**SERVICE BULLETIN**

**APPLICABILITY:** 2015-16MY Outback

**NUMBER:** 15-192-16

**SUBJECT:** Loose / Gapping Accessory Front Wheel Arch Moldings

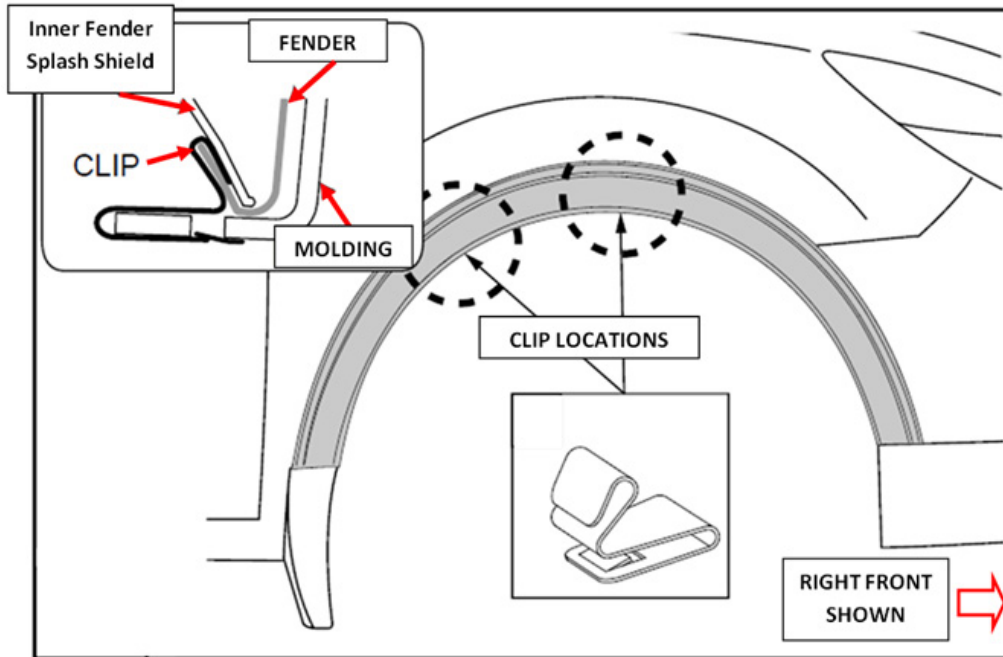
Four new replacement clips come as a kit by ordering p. n. **SOA930H100**. The cross-section illustration below shows the retaining clip locations and how the clip attaches the inner lip portion of the molding to the fender's inner lip.

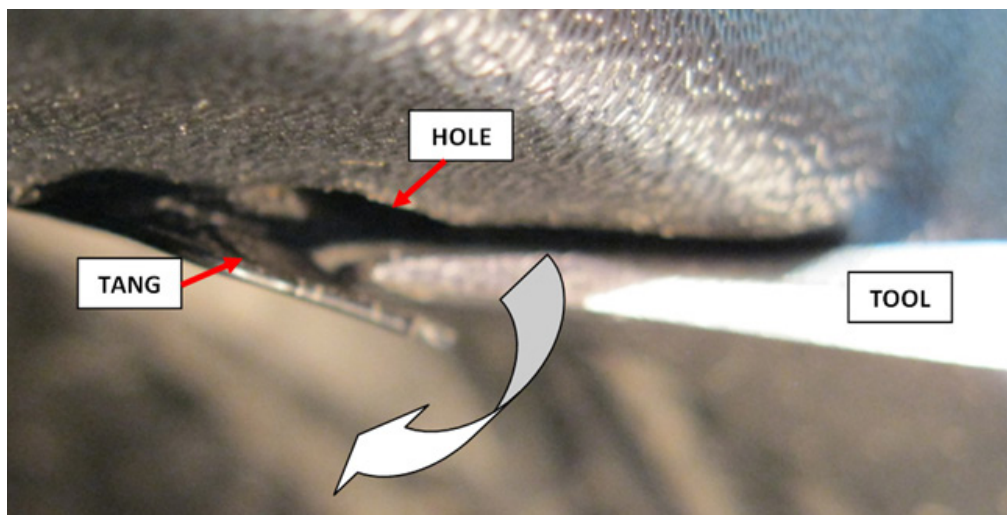
The depth and angle of the lock “tang” portion (circled) of the clip have been changed to provide better retention. The photo shows a comparison between the old and new -style retaining clips.
